REPORT OF THE CHIEF OFFICER PLANNING AND REGULATORY

APPLICATION NO:
P/2021 /0110

LOCATION:
LAND TO THE NORTH AND SOUTH
OF LANE FARM ROSSETT ROAD
TREVALYN ROSSETT WREXHAM
LL12 0DS

DESCRIPTION:
MATERION CADARNHAU YN
BRIODOL I CAIS AMLINELLOL
P/2018/0560 / RESERVED MATTERS
PURSUANT TO OUTLINE
APPLICATION P/2018/0560

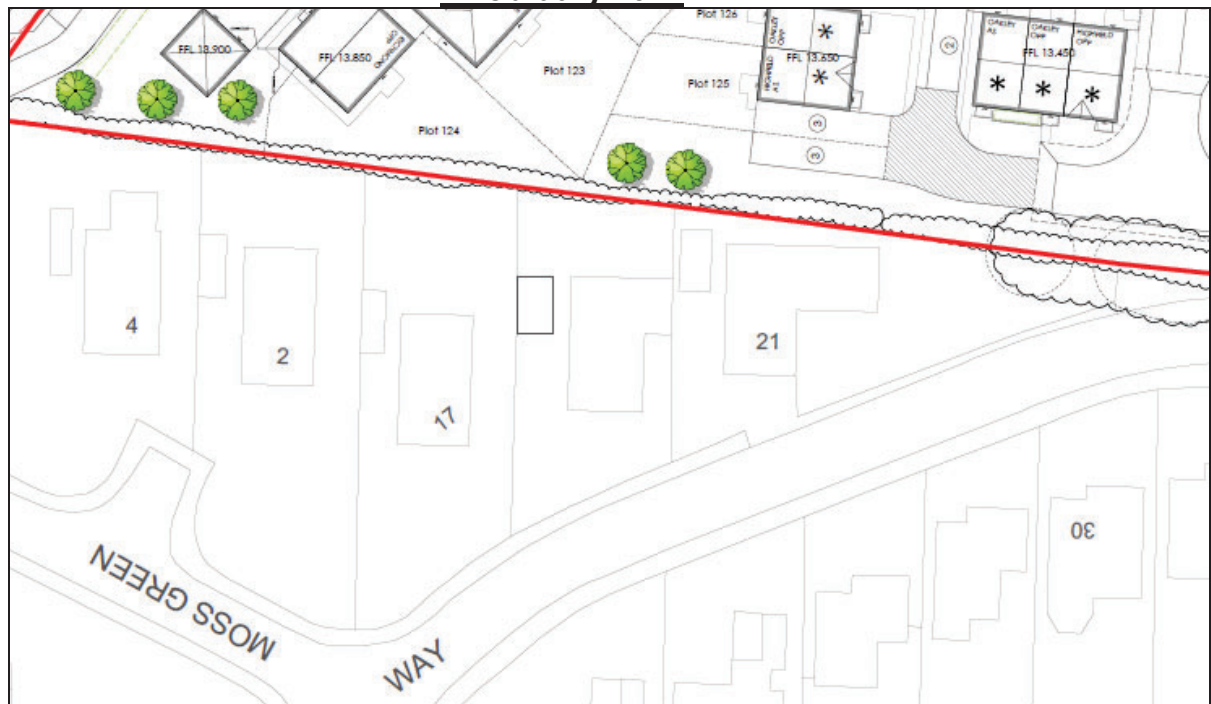
The separation distances between nos. 3-5 Trevalyn Way and plots 9-12 ranges from 21m to 21.75m. Whilst this is marginally below what LPGN21 advises it will not, in this instance, result in any material increase overlooking at either ground or first floor level than if the proposed dwellings were fully compliant with LPGN21 and as such will not adversely impact upon the occupiers of 3-5 Trevalyn Way by way of loss of privacy.

The separation distances between the side elevations of no.9 Trevalyn Way to plots 25-26 are 22.5m and 21.5m respectively first floor to first floor and 22m and 21m respectively when measured ground floor to ground floor. The differences between the first floor and ground floor distances is due to no.9 having a ground floor bay window that projects outwards by approximately 0.5m. The proposed dwellings will have floor levels around 1m above those of no.9 and as a result LPGN21 advises that the separation distance should be 24 metres.

Whilst it is acknowledged that the separation distances are below LPGN21 advice, in this particularly case the windows serving habitable rooms in the front elevations of plots 25 and 26 will not afford any additional views of or into either the ground or first floor windows in the side elevation of no.9 than if both plots were situated 24 metres away. Accordingly, despite not fully according with LPGN21 advice, the development will not adversely impact upon the standard of privacy afforded to the occupiers of no.9 Trevalyn Hall View.
